### Economic Commission for Europe

#### World Forum for Harmonization of Vehicle Regulations

#### Regulation No. 46 (Devices for indirect vision)

### Proposal for 03 series of amendments to Regulation No. 46

Figure A  
Diagram of the blooming measurement set-up.

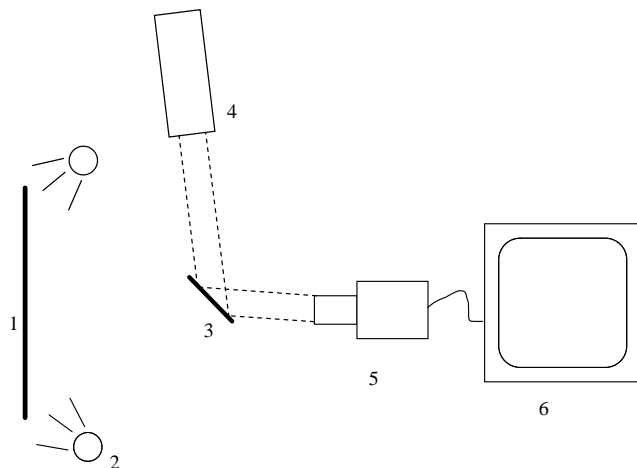
**6.2.2.2.1.2. The camera shall be hit by a (simulated sun) light of 40 kLx, spanning an angle between 0.6 and 0.9 degrees with an elevation angle of 10 degrees (directly or indirectly via a mirror) removed from the optical axis of the sensor.**

**6.2.2.2.1.4. An example of the set-up is given in the figure A below.**

9. As standard EN 12368 related to traffic signal light cannot be applied directly to cameras, the test conditions for the blooming test, which simulates the influence of low sunlight on the performance of a camera, have been redefined in paragraph 6.2.2.2.1 to 6.2.2.2.1.4. Also the area in which the contrast is below a certain value has been set on a maximum of 15 per cent of the image on a monitor. This value is based on the results of comparison test.

Figure 2  
**Typical relationship between the size of the triangle and the fraction of correct responses.**

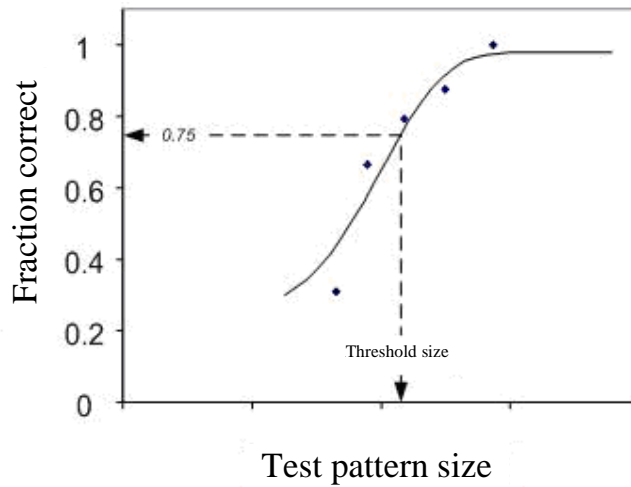
The TNO Landolt C test can be used to determine the smallest discernable detail of the camera-monitor system. However, for sensor systems it is more suitable to use the TOD (Triangle Orientation Discrimination) method which is similar to the Landolt C method, but involves equilateral triangular test patterns. The Triangle Orientation Discrimination method is described in detail by Bijl & Valeton (1999), who provide practical guidelines on how to perform a TOD measurement. In the method, triangular test patterns (see Figure 1) are viewed through the viewing system under test. Each triangle can have one out of four possible orientations (apex up, left, right or down) and the observer indicates/guesses for each triangle its orientation. When this procedure is repeated for many (randomly oriented) triangles of different sizes the fraction of correct responses can be plotted (see Figure 2), and increases with test pattern size. The threshold is defined as the point at which the fraction correct crosses the 0.75 level and can be obtained by fitting a smooth function through the data (see Bijl & Valeton, 1999). Critical perception is reached when the critical object diameter equals two times the width of the triangle at threshold size. The smallest discernable detail ( $\omega_c$ ) is equal to 0.25 times the width of the triangle at threshold size. This means that, from the threshold triangle width  $w$  (in m) and the distance between test pattern and the camera  $D$  (in m) the smallest discernable detail  $\omega_c$  (in arcmin) is calculated as follows:

16. The procedure for calculating the maximum detection distance on the basis of video lines (which is an oversimplified model that should no longer be used) has been replaced by a new procedure based on ophthalmologic tests like Landolt-C or TOD (Triangle Orientation Discrimination) test. This procedure guarantees that the displayed object has sufficient detail and size.
